Delegated Report

Planning Application No: 20221361

Location: Land Adjacent And To The Rear Of Norwood Farm House Norwood Lane
Meopham

Description: Erection of a three-bedroom bungalow with a two-car garage and
associated landscaping.

20200206 Site Layout

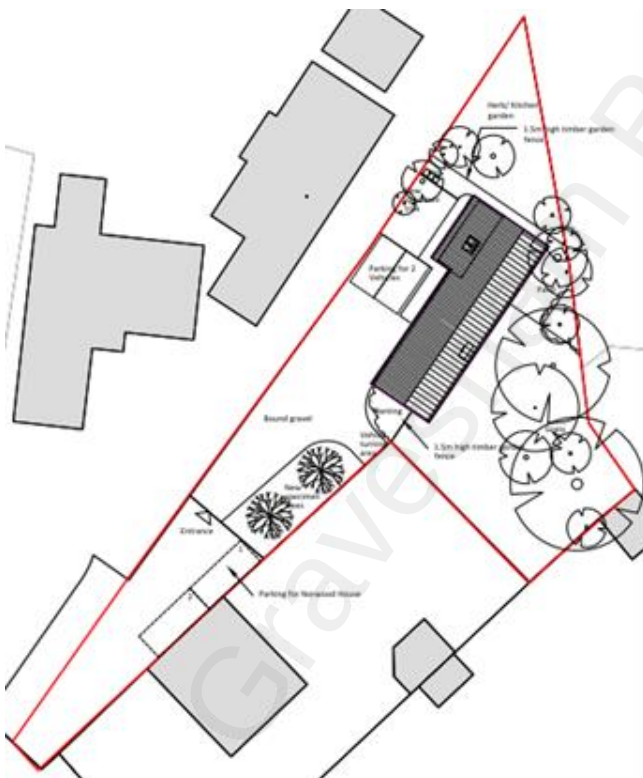
In terms of the current proposal that is before us, the site layout largely remains the same with the proposed garage and position of the proposed dwelling being in a similar position to the parking area and dwelling within the approved scheme. The main difference is the inclusion of a attached double garage and the width and footprint of the dwelling. The current proposed dwelling would be 'L' shaped and would project further to the east behind Norwood Farmhouse than the approved property. It would also include a double garage that would form part of the dwelling and the whole property would be set slightly further back to the north east, with the turning area being partially set behind the rear boundary of Norwood Farmhouse.

20200206 South-West (Front) Elevation

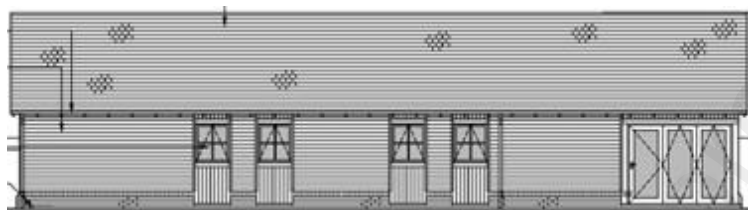
In relation to design, the property would remain as a single storey dwelling, however the mix of pitch and catslide roof has been revised to be a mix of pitch roof and gable. The height of the eaves would slightly increase from 2.73m to 2.94m, however the ridge would increase from 4.96m to 6.85m (a difference of 1.89m).

In terms of width, the current proposal includes an integral double garage and would have an increase width on the south west elevation of 17.67m (including the garage), whereby the approved dwelling has a width of 7.09m and has an open surface parking area to the side.

In terms of appearance, whilst the proposed dwelling would be single storey as previously approved, the increased height of the ridge, together with two large gables to the front and rear would increase the scale and bulk of the property over the previously approved scheme. This, together with the integral double garage, increasing the overall external footprint of the dwelling, and projection further to the east behind Norwood Farmhouse, would result in a dominant and bulky form of development that would not respect its setting and would detract from the Grade II Listed Building.

The previous approval was a modest single storey pitch and catslide property that had a low eaves and ridge height that gave the appearance of simple stable style block, that gave a subservient and respectful appearance to Norwood Farmhouse. The current proposal with the increased height and roof design, would appear more of a two storey dwelling that is similar in bulk and scale to the previously refused scheme under planning reference 20050297.

20200206 Floor Plans

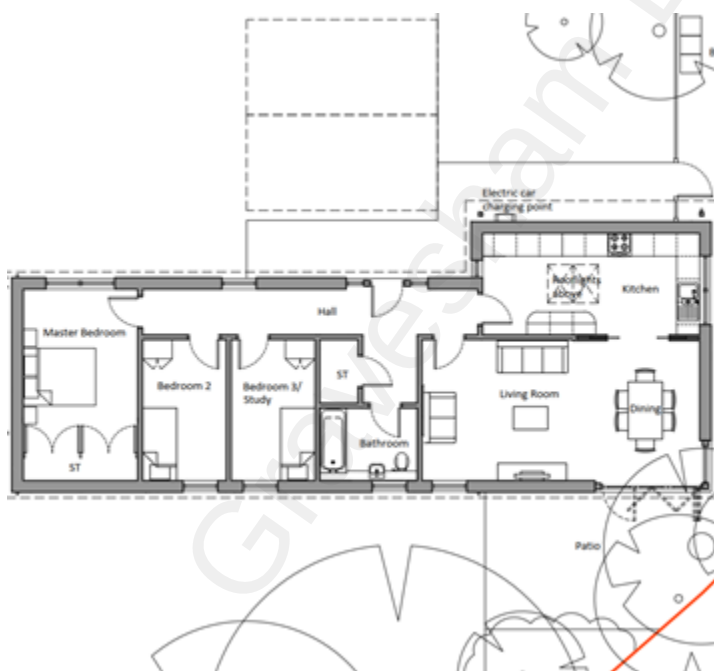
In terms of overall footprint, the approved property has an external footprint of 112.04m² and the current proposal including the garage would have an external footprint of 184.33m².

The current proposal seeks to provide one detached 3 bedroom single storey dwelling. The submitted floor plan indicates the dwelling is designed for 5 people given the size and furniture layout of the proposed bedrooms. Taking account of the nationally prescribed space standards, the gross internal floor area and internal space standards of each dwelling is as follows, based on the floor plans submitted with the application. This assessment does not take account of the discrepancies between the drawings.

Proposed	Standard 3b5p 1 storey dwelling
Total Floor Area	163.12m²	86m²
Master bedroom	16.09m ² 3.34m	11.5m ² 2.75m width
Bedroom 2	11.51m ² 3.26m	11.5 m ² 2.15m width
Bedroom 3	8.04m ² 2.26m	7.5 m ² 2.15m width

As can be seen, based on the floor layout drawings, the gross internal floorspace exceeds the minimum prescribed space standards and the bedrooms exceed the standards both in floor area and width. The proposal would therefore provide a good standard of internal living space for future occupants and would accord with the Technical Housing Standards.
